SERVICE BULLETIN

BULLETIN: 0029
DATE: February 2, 2004
OEM: Komatsu

SUBJECT: JRB® Excavator Hydraulic Kit Swivels

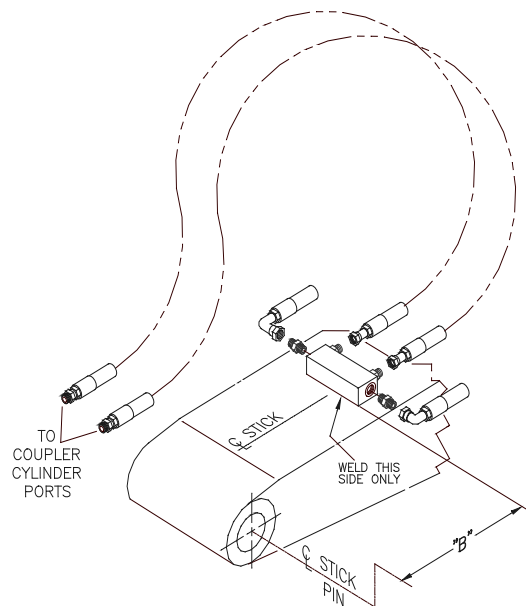
Due to the increased hydraulic pressures of the Komatsu dash 7 excavators, JRB® has designed a modification for the coupler hydraulic kits for these machines. The issues regarding the higher pressures include swivels leaking and “locking up” or “freezing up”. A Manifold Conversion Kit has been developed to correct this problem. If you have a problem with swivels on a customers machine, call JRB® Customer Service at **1-800-428-2538**.

The manifold conversion kit is shipped complete with instructions for installation. The labor for installation is typically less than two hours.
